Groundwater Transfer Review Summary Form

Transfer/PA # T- 14492 (RA)

Application: T-14492

Applicant Name: Mitchell Regal

Well Location Map

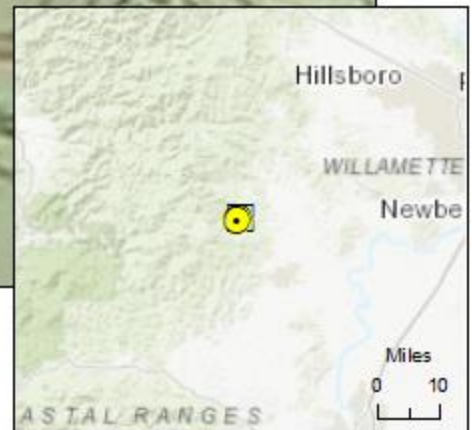
4. a) Will this proposed change, at its maximum allowed rate of use, likely result in an increase in interference with **another ground water right**?
 Yes No Comments: The proposed APOA are not substantially closer to any known neighboring water wells. Therefore, no appreciable increase in interference with neighboring wells is anticipated. However, well-to-well interference in fractured rock systems can be highly variable and difficult to predict depending on the orientation, density, and interconnectedness of water-bearing fractures.

5. a) Will this proposed change, at its maximum allowed rate of use, likely result in an increase in interference with **another surface water source**?
 Yes No Comments: The proposed APOA are not substantially closer to nearby surface water sources. Therefore, no appreciable increase in interference with nearby surface water is anticipated. However, surface water interference in fractured rock systems can be highly variable and difficult to predict depending on the orientation, density, and interconnectedness of water-bearing fractures.
